Applicant: Lectrosonics, Inc.
581 Laser Road
Rio Rancho, NM 87124

Re: Response to Correspondence reference number 31739

Equipment: FCC ID: DBZSMQH, 731-confirmation number EA393044

Photograph showing separation distance from the back of equipment to the antenna.

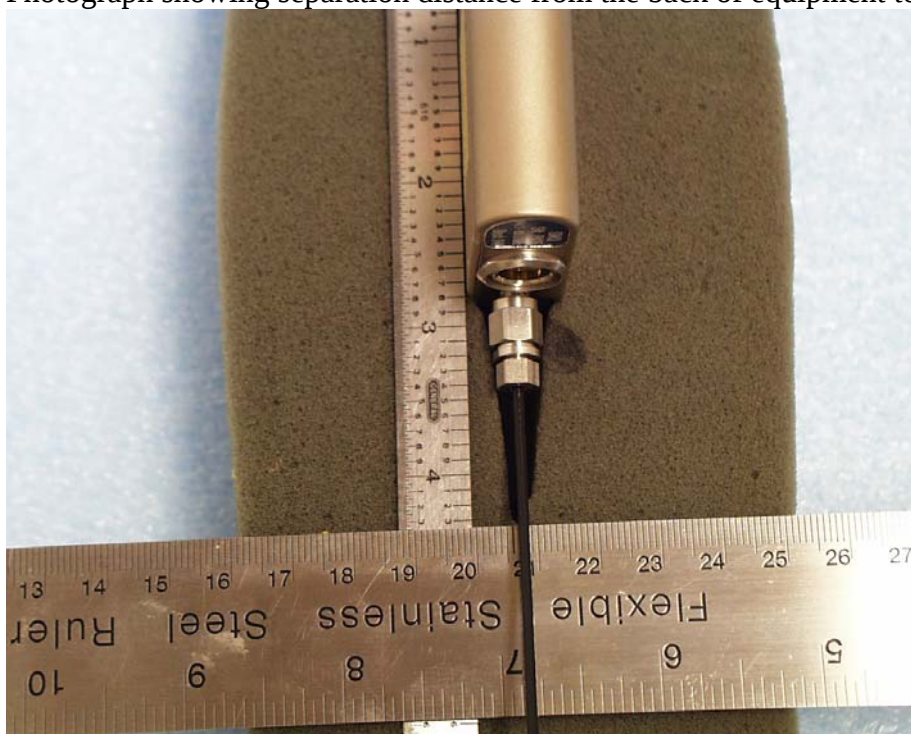
To support FCC RF exposure compliance determination, please submit photos and/or sketches for product with antenna installed showing spacings between the plane of the back of the belt-clip to: a) the back of the device, b) the closest point(s) of installed-antenna(s) FCC will then review all filing info to determine whether other info may need to be requested to support compliance with RF exposure requirements as applicable for all transmitters regulated by FCC. It may help to expedite this review if applicant has available and wishes to voluntarily submit SAR test results for this specific product

Below please find relevant photographs per your request demonstrating spacing between the back of the device and antenna, and the back of the clip and antenna.
